## SPECIAL INSPECTION / LIGHTING PHOTOMETRIC TEST

EOS Fitness  
Lighting Photometric Special Inspection

**Optimized LED Project Number: MCI202002**

DESIGN BY: CRC **PH-1**

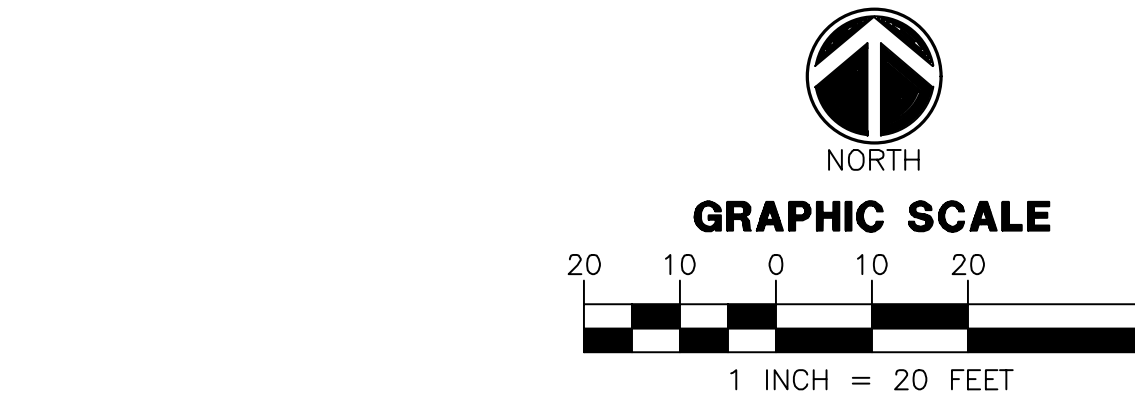
- i. **PASSED – Some points along pathways were less than .5fc, however, once freestanding pole lights are producing full light output this should pass.**

- i. **PASSED – Two light poles appear to produce about 3-times as much light as the other 6 poles. These two poles pass, all points tested around these meet or exceed the ordinance and correspond to computer photometrics. However, the other 6 poles have testing points that are significantly below the City of Tempe requirements of 2.0FC in parking spaces and 1.0FC in drive aisles. Contractor shall coordinate with design team to get all fixture to obtain the same high lumens. OLED will need to return to retest before issuing compliance certificate.**

- k. Parking lot drive aisles shall be illuminated dusk to dawn with one (1) foot-candle.
  - i. **PASSED – Two light poles appear to produce about 3-times as much light as the other 6 poles. These two poles pass, all points tested around these meet or exceed the ordinance and correspond to computer photometrics. However, the other 6 poles have testing points that are significantly below the City of Tempe requirements of 2.0FC in parking spaces and 1.0FC in drive aisles. Contractor shall coordinate with design team to get all fixture to obtain the same high lumens. OLED will need to return to retest before issuing compliance certificate.**
